Upgrade Information of MPE720 Version 5.44

Items added and features improved from MPE720 version 5.43 to version 5.44 are as follows.

No.4 Support to sequence program function.

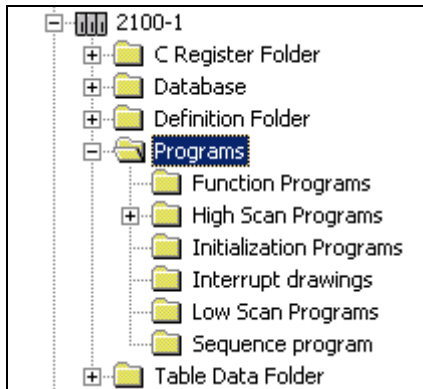
It supported to the sequence program function with MP2100/MP2100M.

No.5 Support to CF card transfer function.

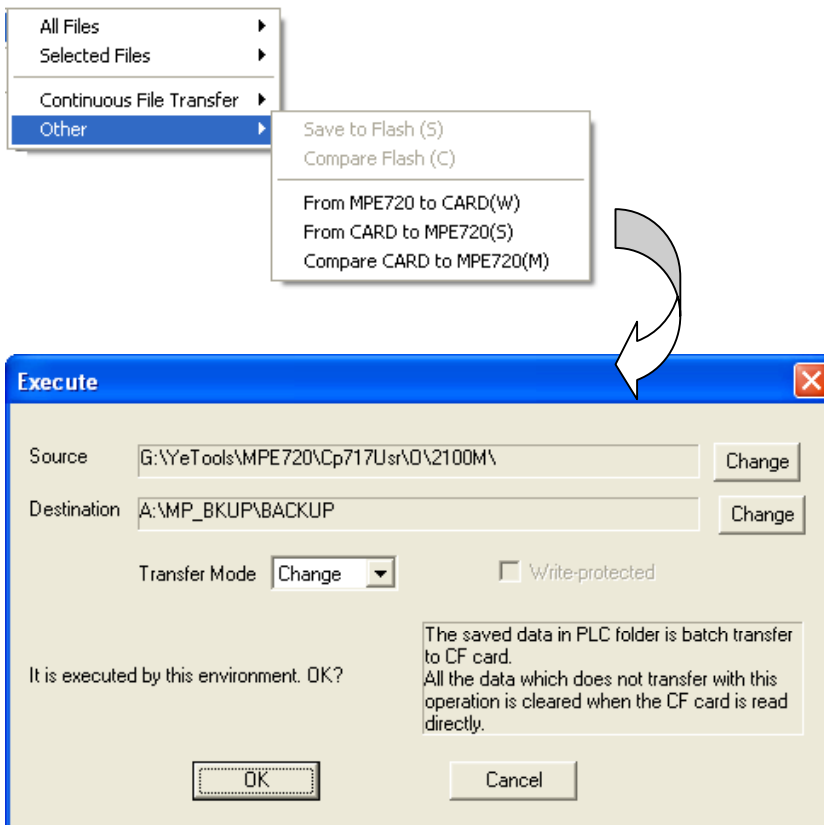
The CF card transfer function that had been supported up to now only when MP2200-02 was selected was developed with the MP2000 series all models.

No.6 Improvement of transfer function.

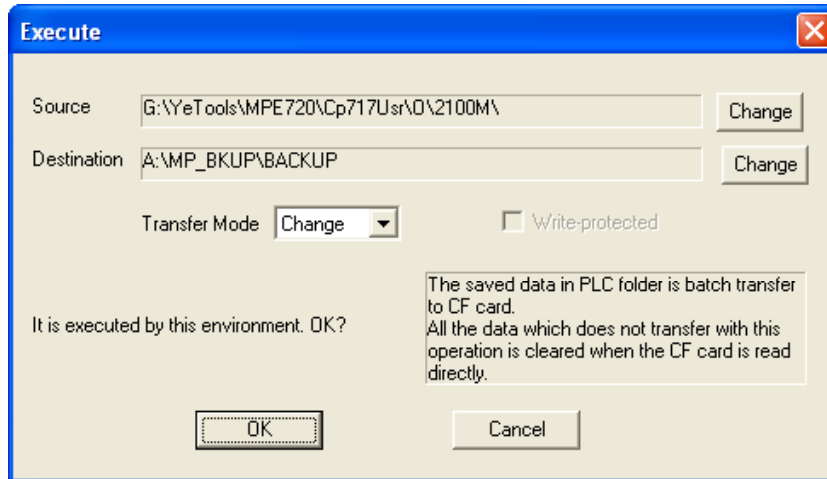
In transfer, when the compression transmission is selected, an internal transfer mode is transferred by "New".

However, it was displayed on the transfer screen, "Change".

Therefore, the transfer mode when the compression transmission was selected displayed, "New".

No.8 Improvement of installer.

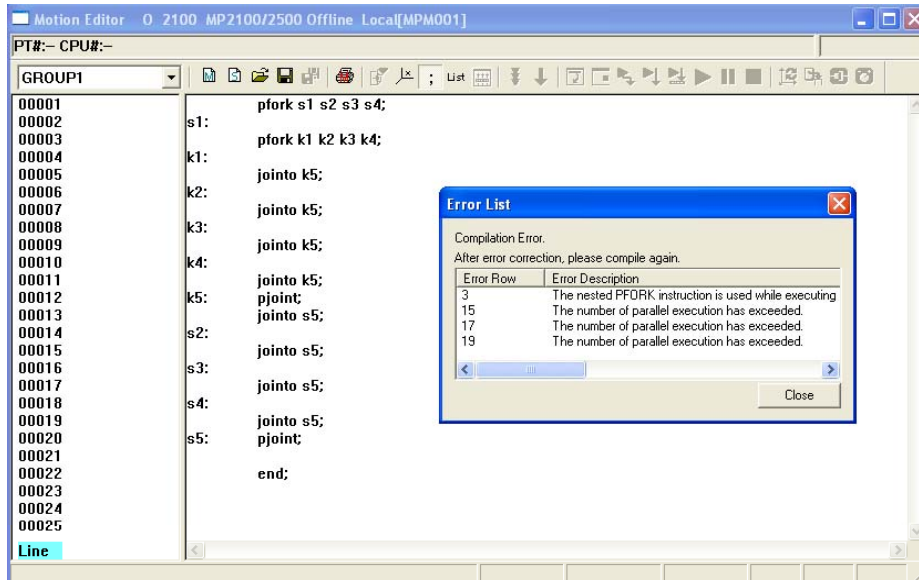
The problem that the installation of MPE720 is not normally completed occurred according to the application installed in the PC environment used beforehand occasionally. Therefore, this was corrected.

No.11 Improvement of motion program PFORK-SFORK saving.

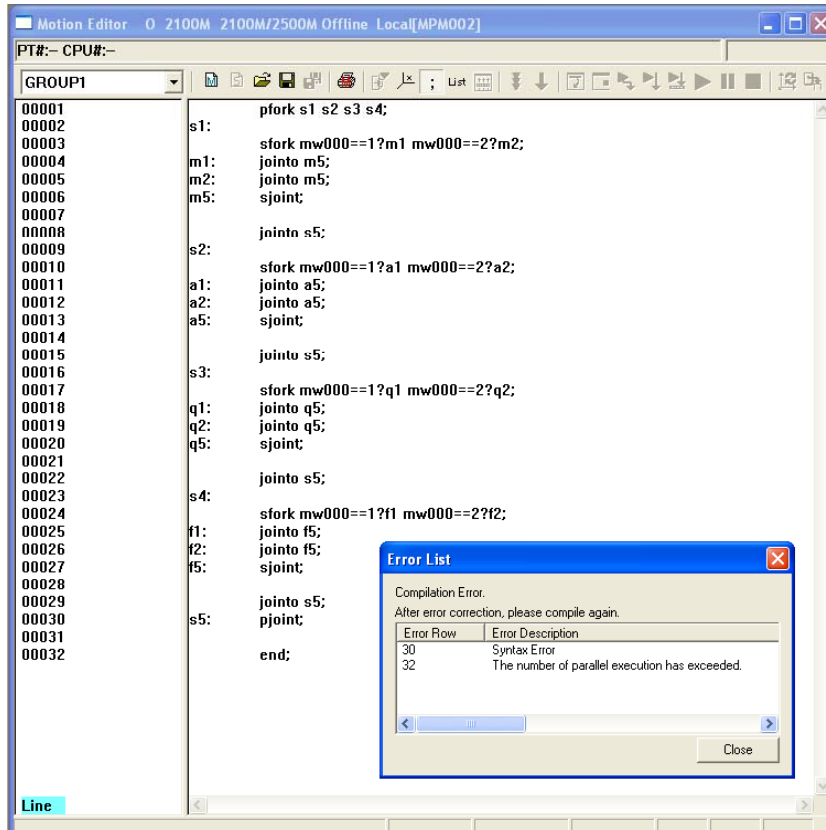
The number of parallel execution occurred when four diverged parallel because of the PFORK instruction, and the SFORK instruction was used in each parallel processing and, up to now, the error of "The number of parallel execution has exceeded." had occurred in spite of in the limitation. Therefore, this was corrected.

No.12 Improvement of new ladder cross reference trouble.

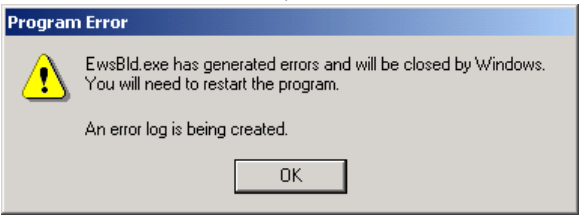
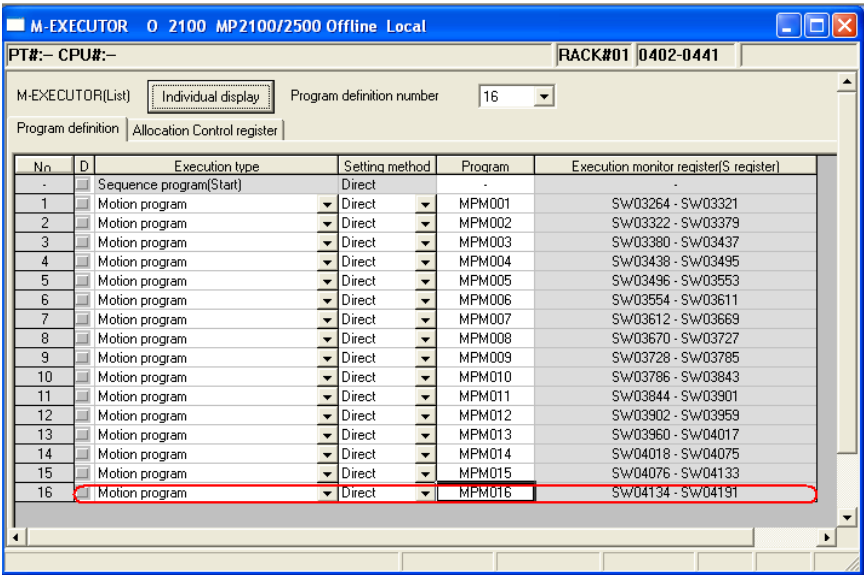
The expression of two or more lines is described in Expression, the following symbols and registers are described in that, and the operational expression that exists together is described.

Symbol allocation: SYMBOL1=MW900;
* The symbol allocations are not in MW000 and MW001.

Under such a condition, there was a problem that assumed that symbol "SYMBOL1" was allocated to MW001 as a crossing retrieval result when MW001 was retrieved and was retrieved. Therefore, this was corrected

No.18 Mistake of current step in PFORK at debugging mode.

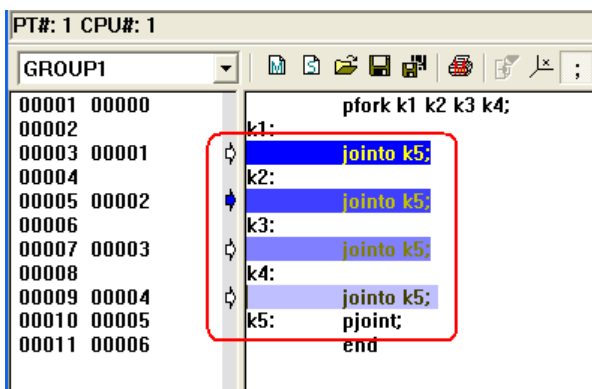
A current execution step had moved to the second parallel divergence when step into/step over to PFORK. This was corrected because there was such a problem.

No.21 Trouble when the current value of SERVOPACK is acquired.

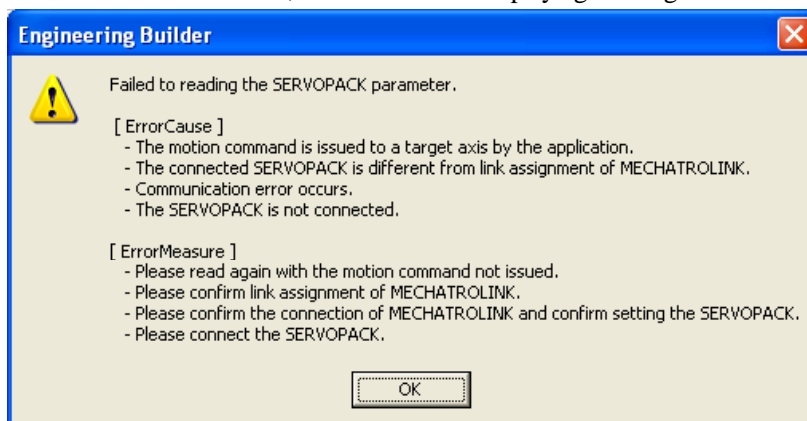
Even if reading failed in the acquisition of the current value from SERVOPACK, it was normally occasionally displayed that it had ended. Therefore, it corrected it like displaying warning.

No.22 Bug of motion program saving privilege.

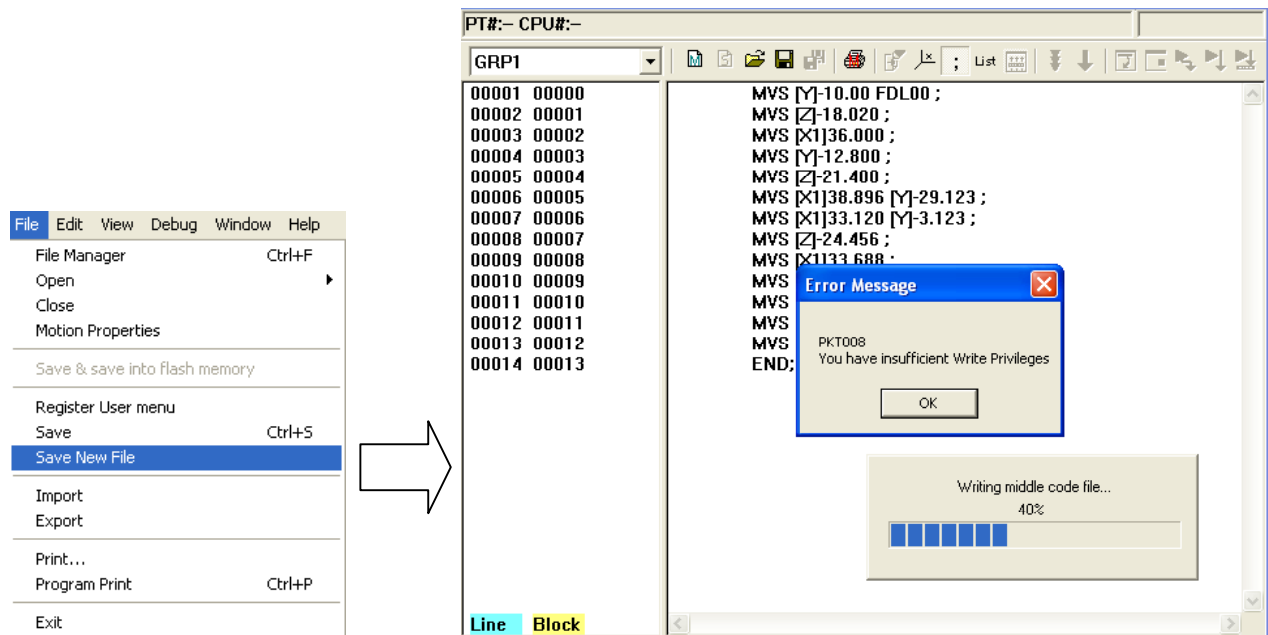
Because the error "You have insufficient Write Privileges" occurred if "Save New File" was executed for an existing motion program and it was not possible to save it, this was corrected.

No.23 Bug of simple mode display.

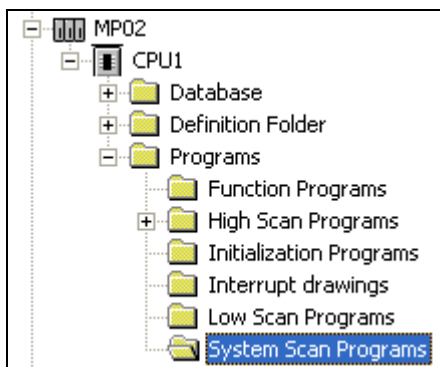
When a simple mode was selected, "System Scan Programs" was being displayed even by the controller who was not supporting to "System Scan Programs" in the file manager. Therefore, this was corrected

No.24 Bug of motion program single quote use.

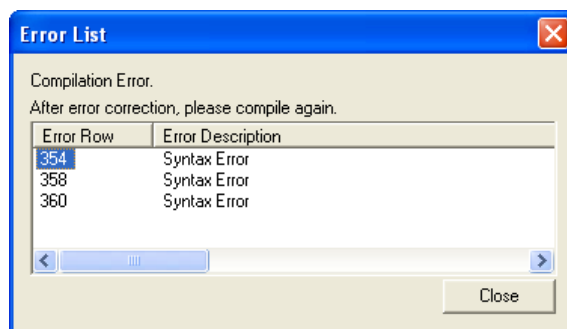
When a single quote was used while commenting on the motion program, the compile error was occasionally generated. Therefore, this was corrected.
